SUNDRY NOTICES AND REPORTS ON WELLS

Well: Lovington Paddock Unit #89

Chevron Midcontinent, L.P.
NMLC-058418: Lovington Paddock Unit #89
API: 30-025-31148
Lea County, New Mexico

RE: Plugging and Abandonment Requirements – Conditions of Approval

Current
Wellbore Diagram

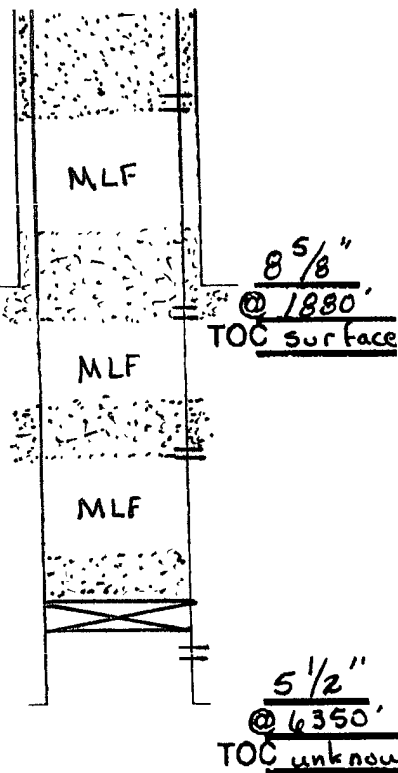
1. Notify BLM 24 hrs prior to MI and RU.
2. RIH set TAG PBTD at 5965', spot 25sx, plug from 5965'-5765'.
3. Displace hole w/MLF, 9.5# Brine w/25# gel P/BBL.
4. Perf 4 holes at 3225, sqz 75sx cement from 3225'-2950' (Yates/B.Salt). WOC&TAG.
5. Perf 4 holes at 2273', sqz 100sx cement plug from 2273'-1880' (T-Salt/shoe) WOC&TAG.
6. Perf 4 holes at 400', sqz 110sx cement plug from 400'-surface' (Shoe/Fr. Wtr./surface) WOC&TAG.
7. Install dry hole marker.

1. OK
2. OK (Perfs)
3. OK
4. Tag at 2950' or shallower. If injection rate cannot be established, spot cement 50' below perforations – Otherwise OK (Yates – BOS)
5. Tag at 1880' or shallower. If injection rate cannot be established, spot cement 50' below perforations – Otherwise OK (TOS – Casing shoe)
6. If injection rate cannot be established, spot cement 50' below perforations – Otherwise OK (Surface)
7. OK – Verify cement to surface in all annuluses.
8. Submit a subsequent report to the BLM.
